# London Luton Airport Expansion

Volume 8 Additional Submissions (Examination)  
**8.118 Applicant's Response to Issue Specific Hearing**  
**4 Action 7 - Updates on Road Safety Audits (Tracked**  
**Change Version)**

Application Document Ref: TR020001/APP/8.118

Figure 3.1: Existing Tree Locations – A602 Park Way

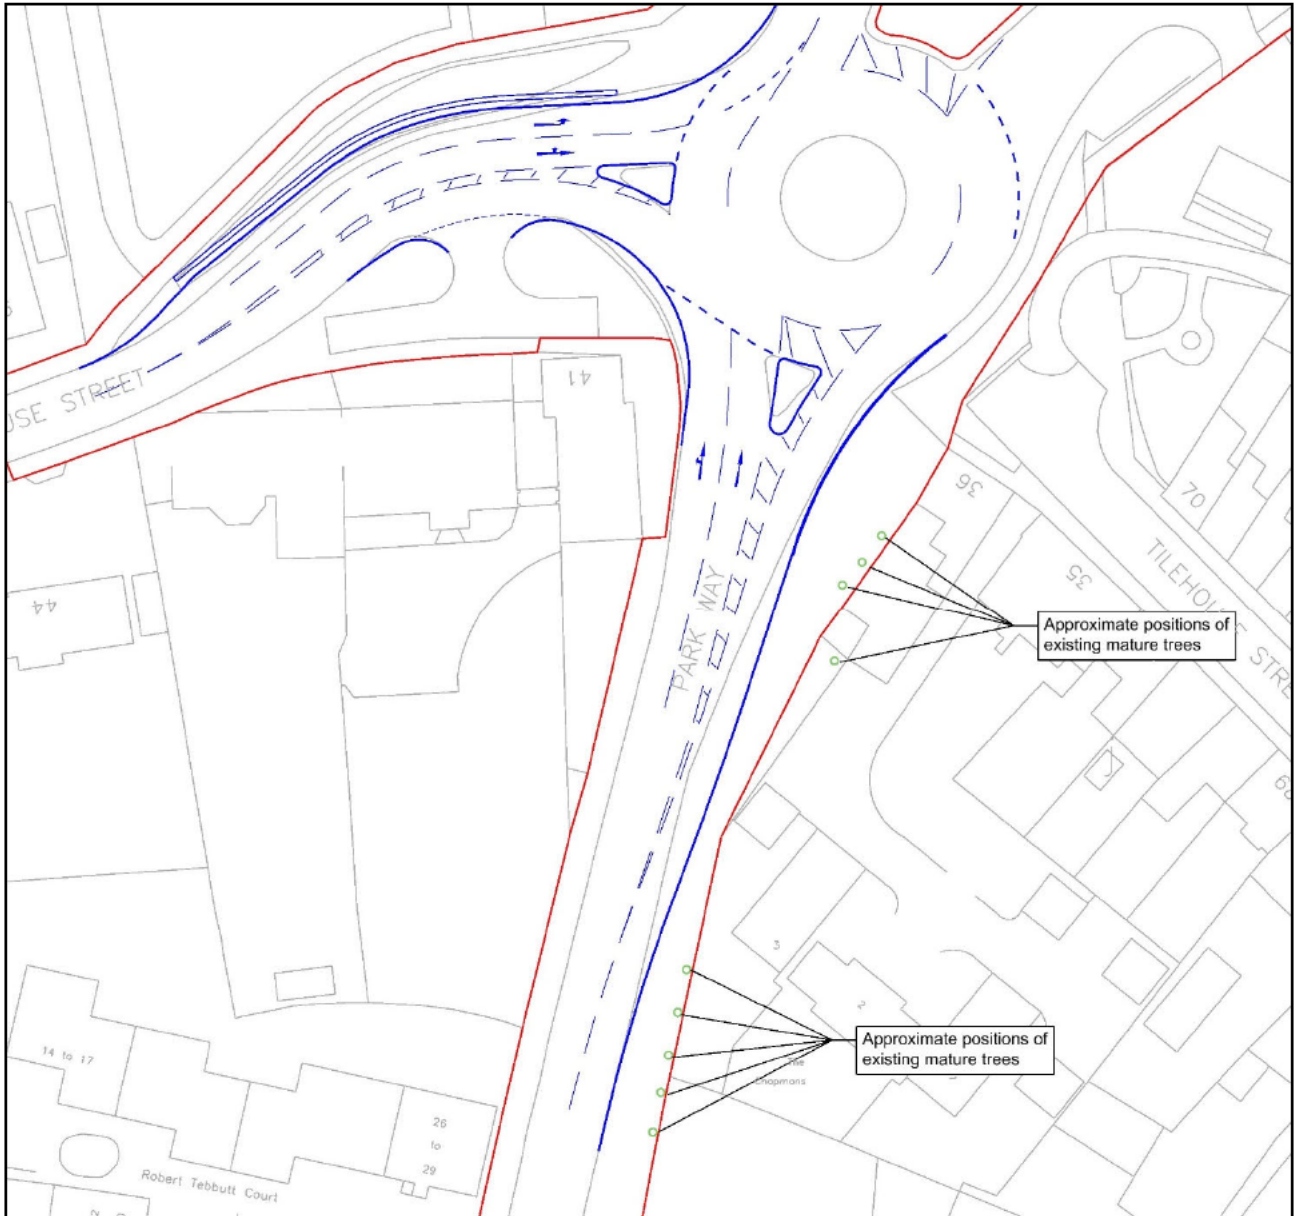
| Ref. | RSA Problem   | RSA Recommendation   | Design Organisation Response   | Overseeing Organisation Response  | Agreed RSA Action |
|------|---|--|--|---|-------------------|
| 3.2  | There are mature trees, dense vegetation, signs and lamp columns on the eastern side of Park Way, that could be impacted by the carriageway widening works. If these items are positioned close to the edge of carriageway, there could be an increased risk of them being struck by errant vehicles, resulting in injury to road users.                      | It should be ensured that any dense vegetation and mature trees are removed if they are likely to be positioned close to the edge of carriageway and other items of street furniture relocated as necessary. | Accepted. Figure 3.1 shows the indicative locations of mature trees in the area where road widening is proposed. The mature trees are within the Hitchin Conservation Area but do not have Tree Preservation Orders. <u>They are generally located close to the highway boundary and would not be close to the widened road carriageway edge.</u> It is not therefore expected | <u>Disagree: Mature trees are unlikely to be removed to make way for these works. Further scheme detail will be required to show which trees are affected: This may change the nature of the scheme, easily leading to it being undeliverable. In short, the designer organisation response is not feasible/practical solution.</u> |                   |

3.2.1 Figure 3.1, below, shows the existing tree locations along the eastern side of A602 Park Way, together with the proposed Order Limit.

Figure 3.1: Existing Tree Locations

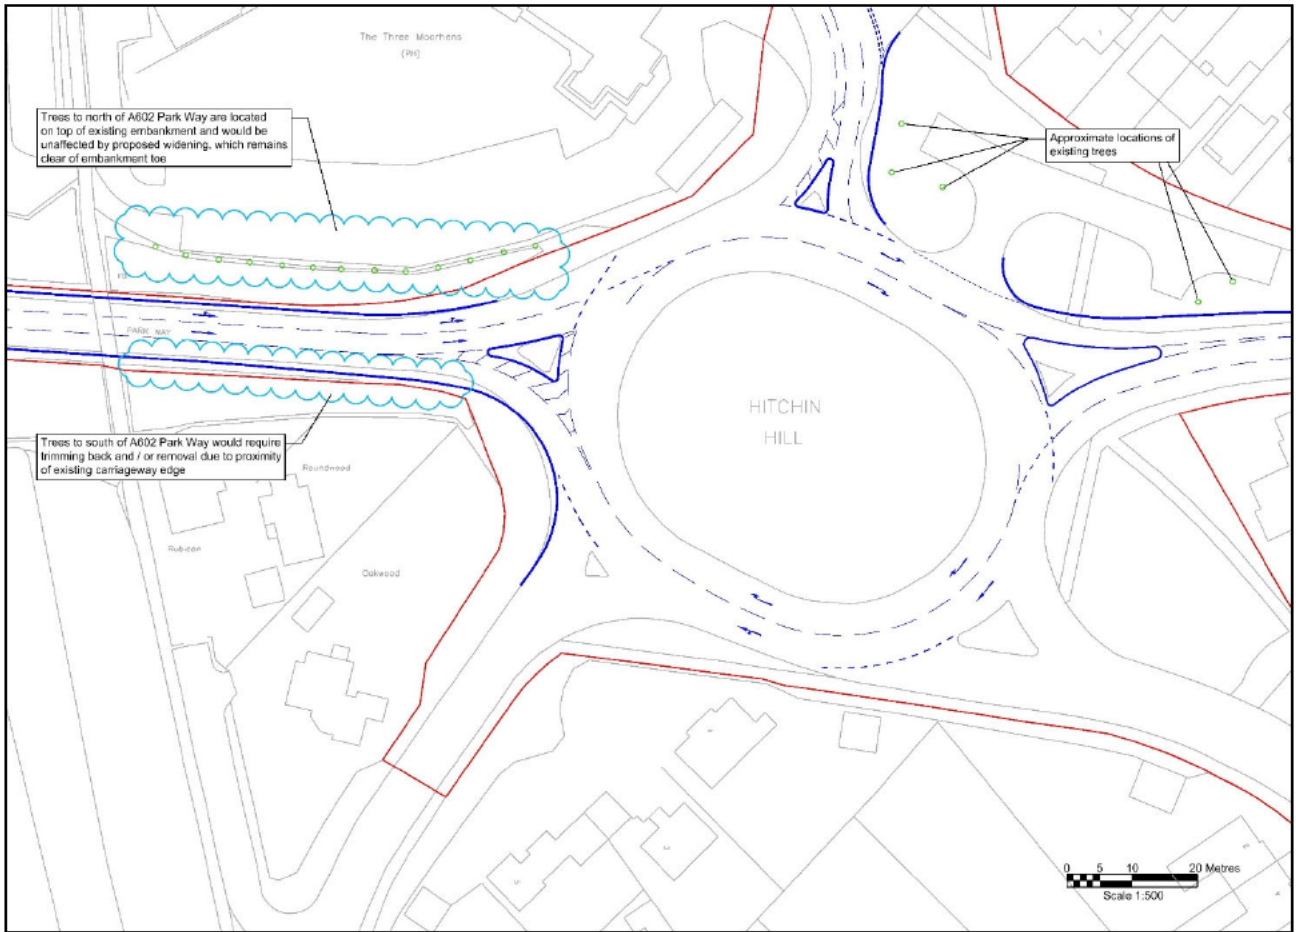
| Ref. | RSA Problem  | RSA Recommendation   | Design Organisation Response  | Overseeing Organisation Response   | Agreed RSA Action |
|------|--|--|---|--|-------------------|
| 3.2  | There are mature trees, dense vegetation, signs and lamp columns on Park Way, that could be impacted by the carriageway widening works. If these items are positioned close to the edge of carriageway, there could be an increased risk of them being struck by errant vehicles, resulting in injury to road users. | It should be ensured that any dense vegetation and mature trees are removed if they are likely to be positioned close to the edge of carriageway and other items of street furniture relocated as necessary. | Accepted. <u>Figure 3.1 shows the indicative locations of mature trees in the area where road widening is proposed. The trees are not within the Hitchin Conservation Area (HCA) and do not have Tree Preservation Orders.</u><br><u>The trees on the north side of A602 Park Way are on an embankment and are set back from the road carriageway edge where it is not therefore expected that the trees would need removing.</u><br><u>On the south side, it is likely that some trees</u> | <u>Disagree: Mature trees are unlikely to be removed to make way for these works. Further scheme detail will be required to show which trees are affected: This may change the nature of the scheme, easily leading to it being undeliverable. In short, the designer organisation response is not feasible/practical.</u> |                   |

| Ref. | RSA Problem   | RSA Recommendation   | Design Organisation Response  | Overseeing Organisation Response  | Agreed RSA Action |
|------|---|--|---|---|-------------------|
| 3.3  | <p>There are numerous heavy-duty items of street furniture, such as lamp columns, utility cabinets and a telegraph pole, in addition to mature trees, that will be impacted by the carriageway widening works. If these items are positioned close to the edge of carriageway, there could be an increased risk of them being struck by errant vehicles, resulting in injury to road users.</p> | <p>It should be ensured that street furniture is relocated, and mature trees removed as necessary as part of the widening works.</p> | <p>Accepted. <u>Figure 3.1 shows the indicative locations of mature trees in the area where road widening is proposed. The trees are not within the Hitchin Conservation Area (HCA) and do not have Tree Preservation Orders. Nevertheless, there is flexibility in the design of the Hitchin Hill approach to move the kerbline away from the closest trees by reducing the lane widths and/or the central hatched area – this is shown on Figure 3.1. The mature trees on the north side of the A602 westbound approach are</u></p> | <p><u>Disagree: Mature trees are unlikely to be removed to make way for these works. Further scheme detail will be required to show which trees are affected: This may change the nature of the scheme, easily leading to it being undeliverable. In short, the designer organisation response is not feasible/practical.</u></p> |                   |

3.2.1 Figure 3.1, below, shows the approximate locations of existing trees in the vicinity of the A602 Park Way / Hitchin Hill arms of the junction, together with a potential minor amendment to the Hitchin Hill arm of the junction to minimise potential impact on trees to the east.

Figure 3.3: A1081 New Airport Way / B653 Gipsy Lane Link SSD

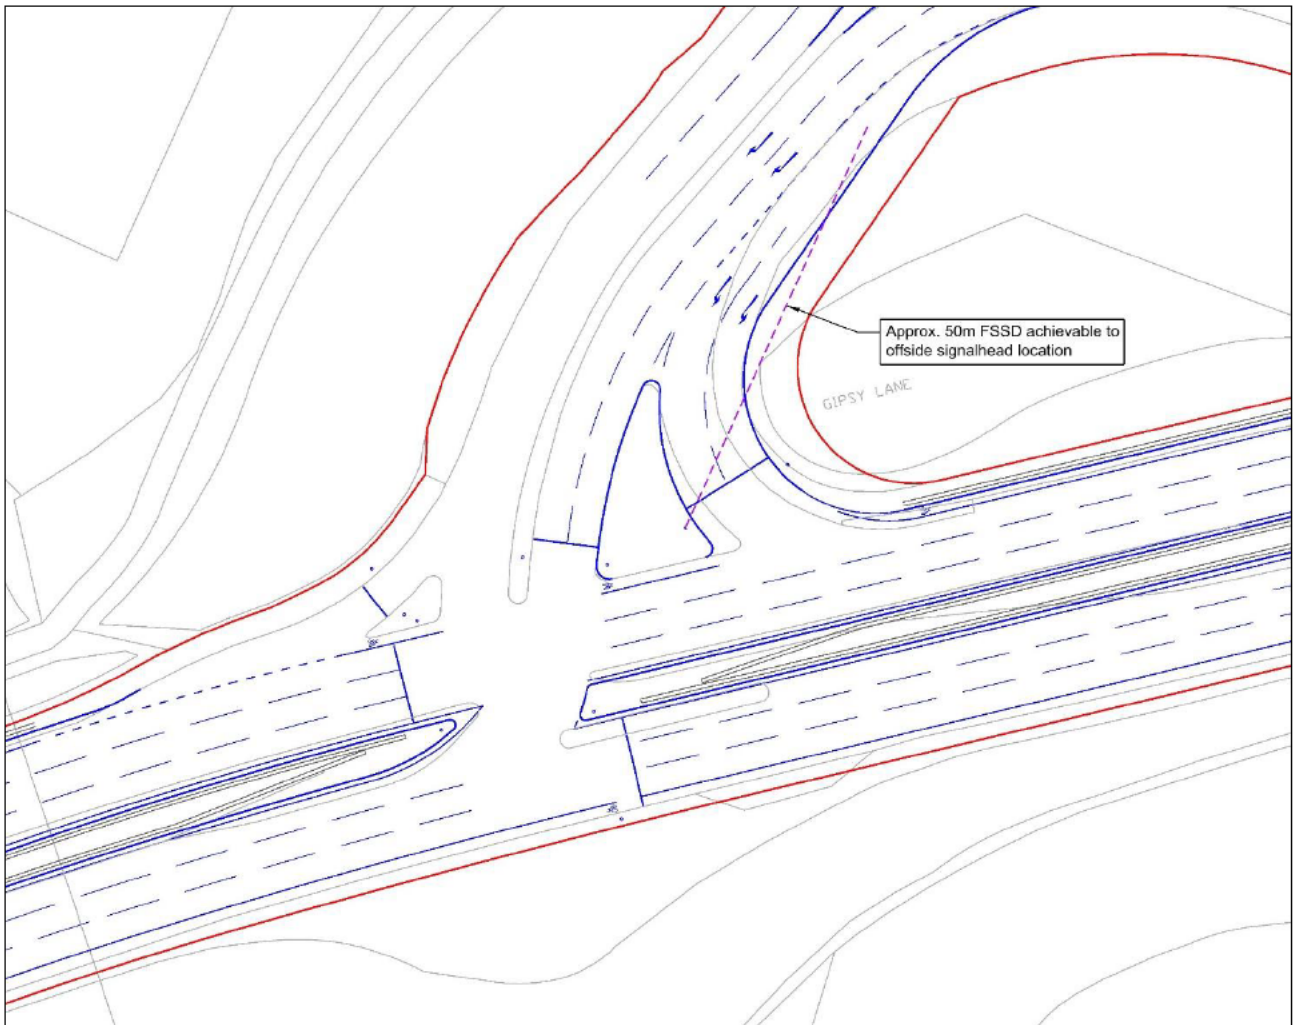
3.2.23.3.1 [Figure 3.3](#) above shows the proposed SSD to the offside signalhead. A SSD of at least 50m SSD to a primary signalhead for the left turn is achievable (covering the entirety of the left turn lanes) without removing significant amounts of trees, which is an improvement over the current SSD of approximately 38m.

[Figure 3.4: A1081 New Airport Way- Proposed Layout](#)

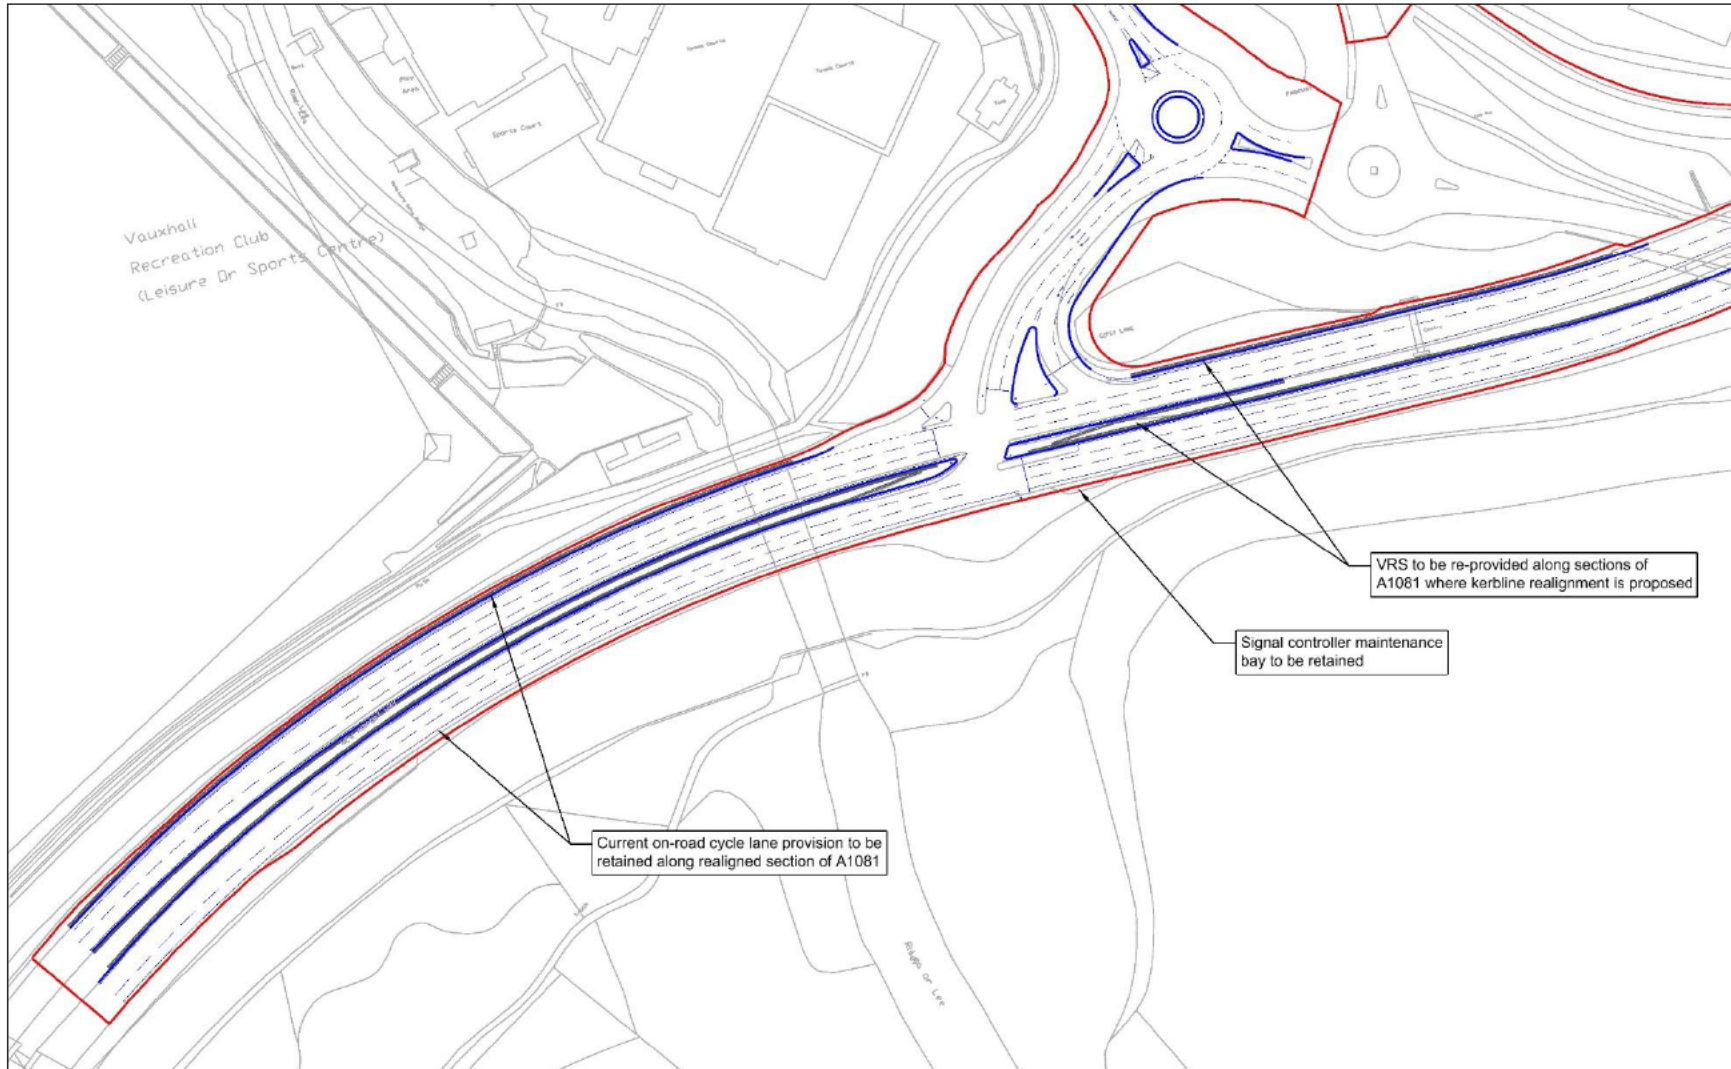
3.4.2 Figure 3.4, above, shows the proposed design of the A1081 New Airport Way, which demonstrates that the existing cycle facilities can be retained within the proposed layout. The existing signal maintenance layby to the south of the junction is also retained in its current location. VRS is indicated along both sides of the A1081 and within the central reserve area, which would need to be re-provided in areas where the kerblines are proposed to be amended.

Figure 3.5: Indicative A1081 Cross Sections

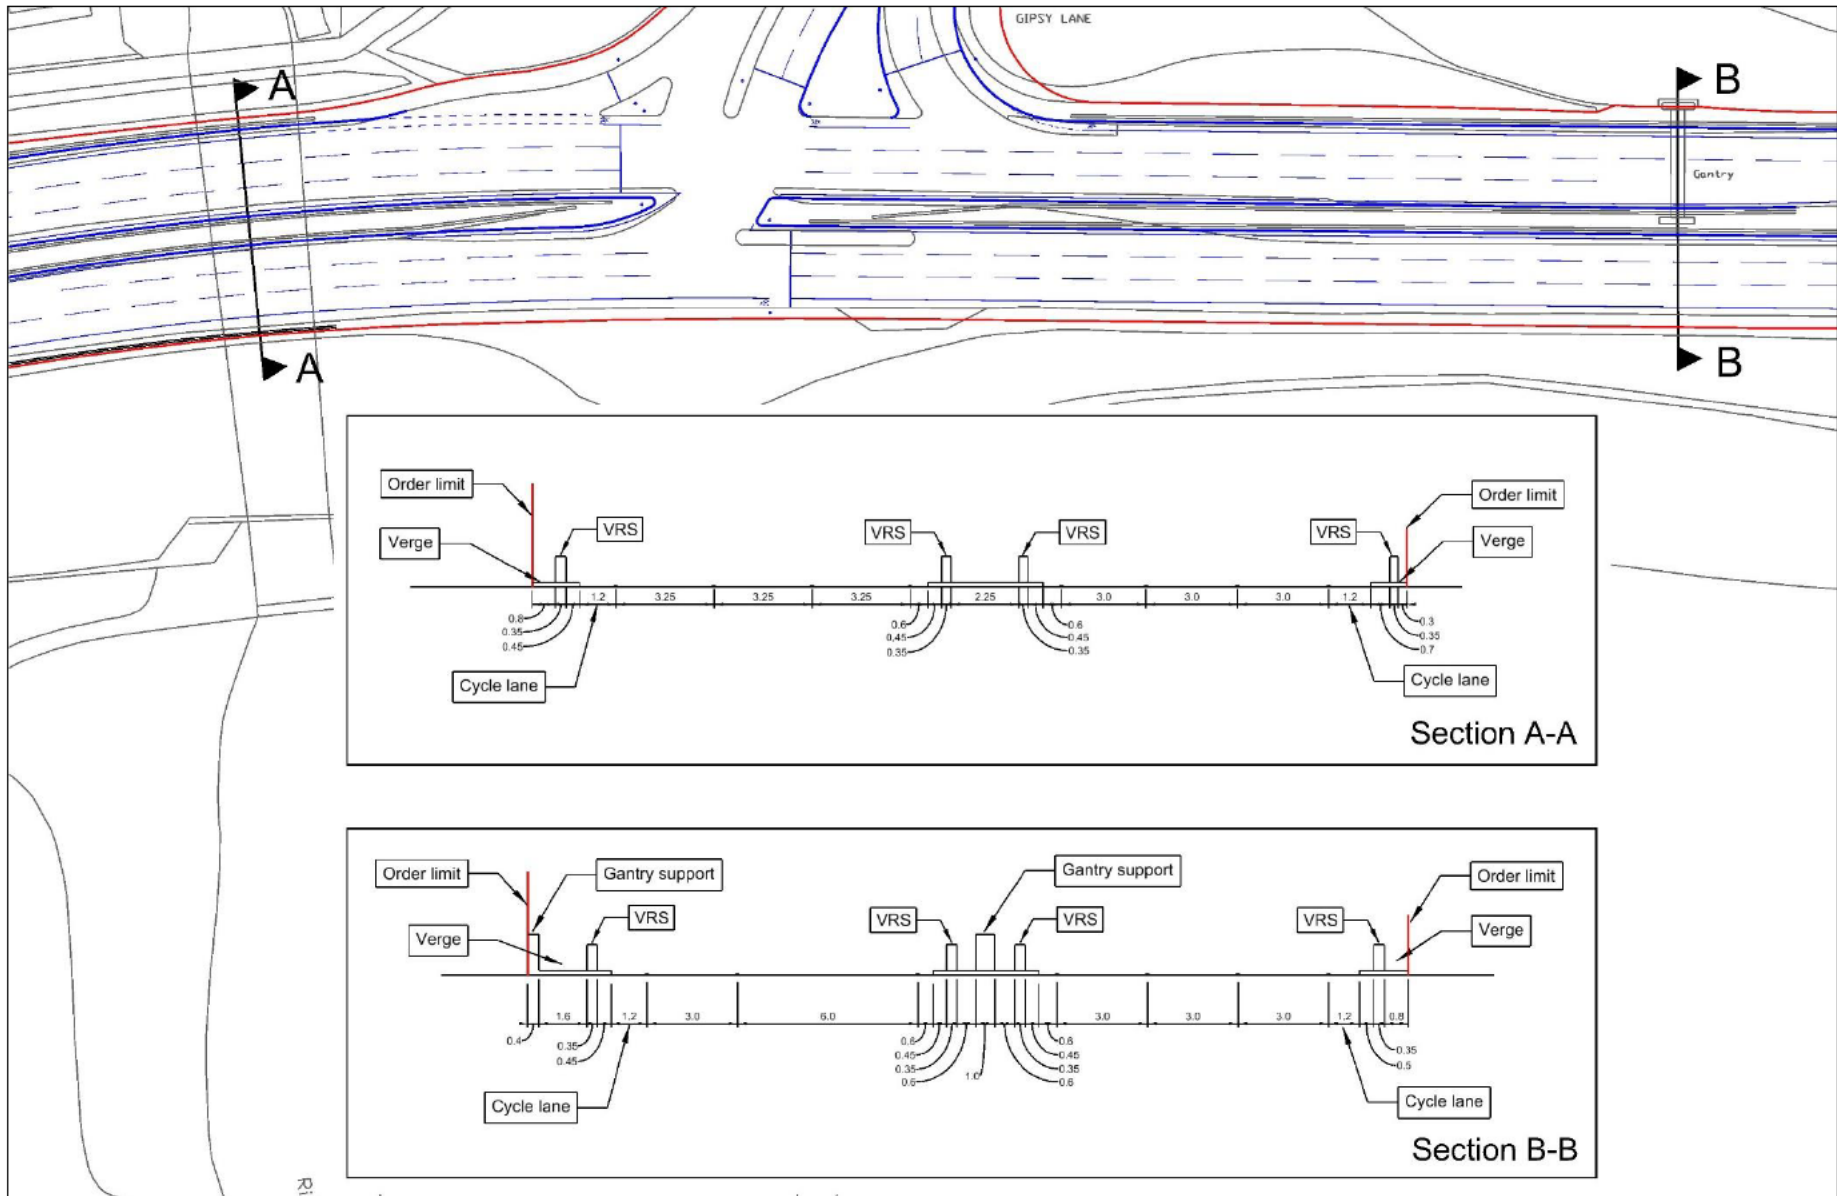
3.5.1 Figure 3.5, below, shows indicative cross sections at two locations along the proposed A1081 New Airport Way alignment, to the east and west of the junction. The western cross-section (Section A-A) is located at the narrowest point of the central reserve, noting that there is potential to reduce the length of three to two lane westbound merge, which would increase the central reserve width to the west of the cross section by up to 1m. The eastern cross-section (Section B-B) demonstrates that there remains a significant clearance between the proposed realigned northern kerblines and gantry foundation.

Figure 3.1: Forward Stopping Sight Distance to Signalhead

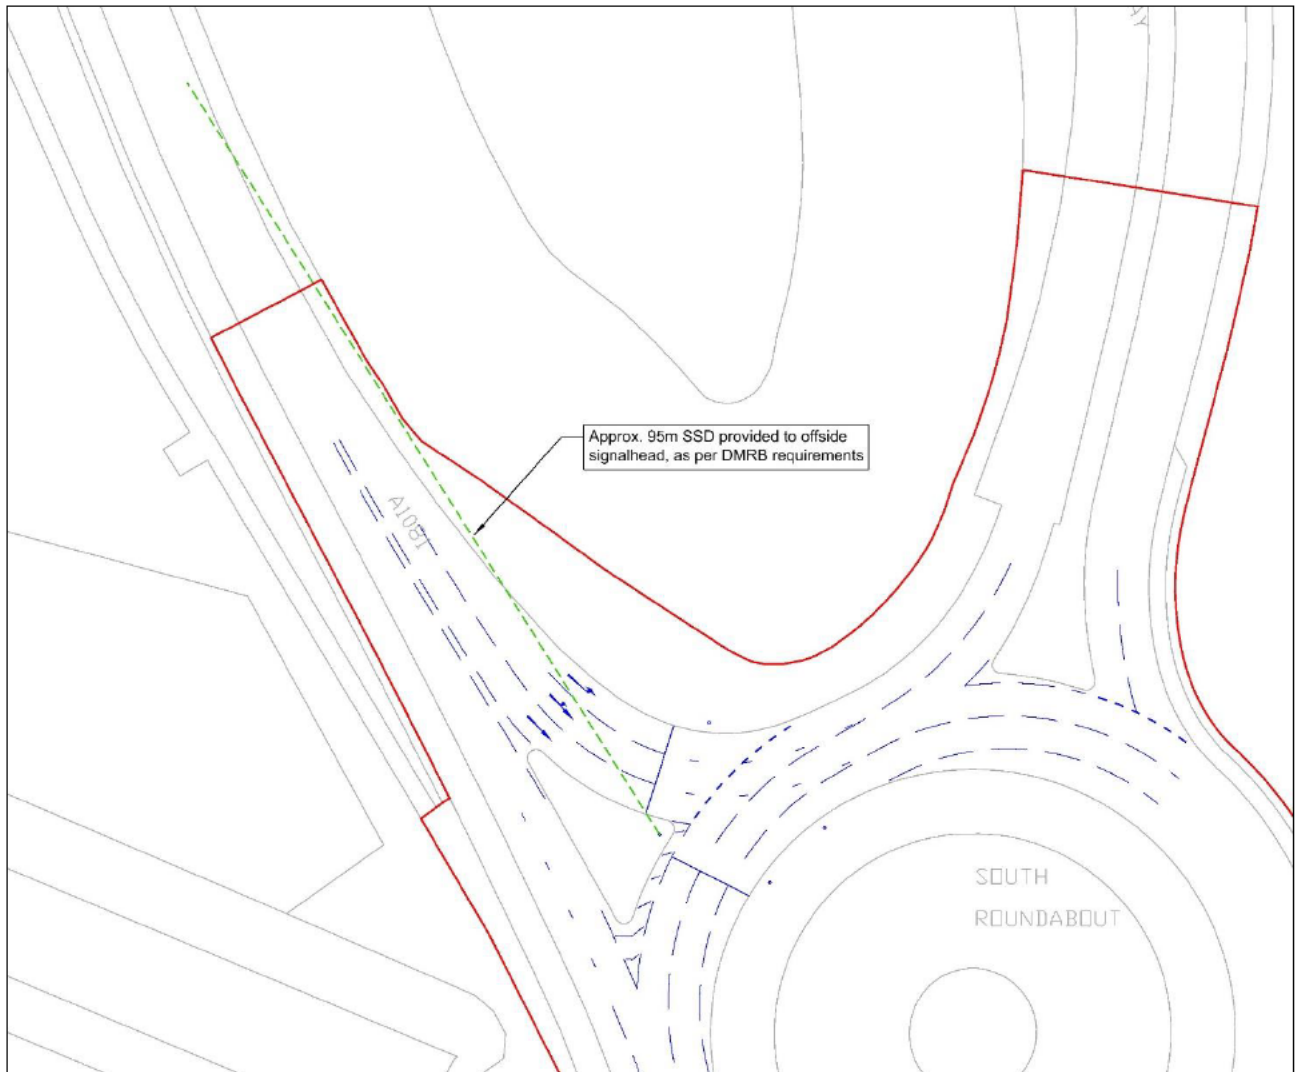
3.2.1 Figure 3.1, above, shows that the Desirable Minimum FSSD to the offside signalhead can be achieved in line with DMRB guidance for a 30mph speed limit (90m). Paragraph 4.7 of CD116 states:
